Office Action Summary

10/705,389

Bradley L. Sisson

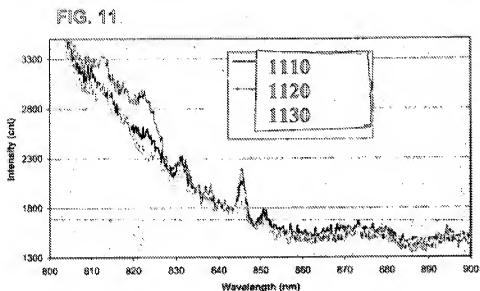
11. In accordance with claims 53, 54, 63, 64, 73, 74, 83, and 84, one is to hybridize a primer to the template and to use a polymerase to attach a nucleotide to the 3' end of the primer. In recognizing that each of said claims depends from an independent claim, and that each of said independent claims requires the addition of a modified nucleotide to the partially double-stranded template nucleic acid, the aspect of hybridizing a primer would result in there being a plurality of sites at which a nucleotide is being added. Further, with said claims requiring the use of a polymerase, all remaining claims fairly encompass practicing the claimed method where no polymerase is being used. A review of the disclosure fails to find where applicant had enabled the method by use of anything other than a polymerase.
